VALIDATION AND VERIFICATION REPORT  
OF UNITÁN AFFORESTATION AND  
REFORESTATION OF GRAZING LANDS  
PROJECT

Document Prepared by AENOR INTERNACIONAL S.A.U.

<b>Project Title</b>	UNITÁN AFFORESTATION AND REFORESTATION OF GRAZING LANDS PROJECT
<b>Report Title</b>	VALIDATION AND VERIFICATION REPORT OF UNITÁN AFFORESTATION AND REFORESTATION OF GRAZING LANDS PROJECT
<b>Version</b>	3.4
<b>Report ID</b>	2022811_Val_ver_report_Unitán_VCS
<b>Verification Period</b>	16 September 2016 to 15 August 2021
<b>Client</b>	ProSustentia
<b>Pages</b>	105
<b>Date of Issue</b>	29/11/2022

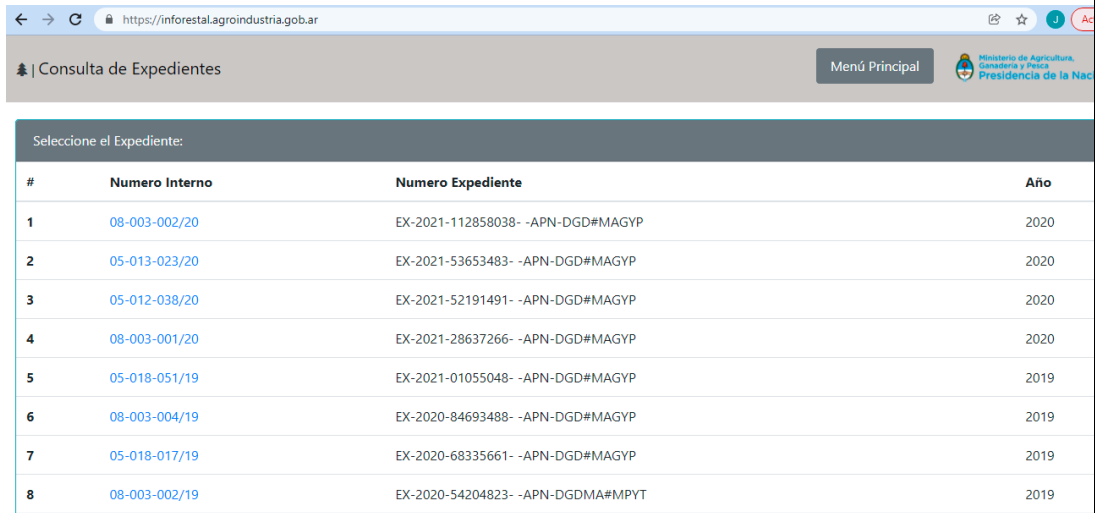
6)

- 2. The information has been updated and it is deemed clear
- 3. The information has been updated and it is deemed correct.

- 1. You are correct, it is not working currently for document research, but using "Unitan S.A.I.C.A" under "Titular" the webpage works and allows to check all the documents available:
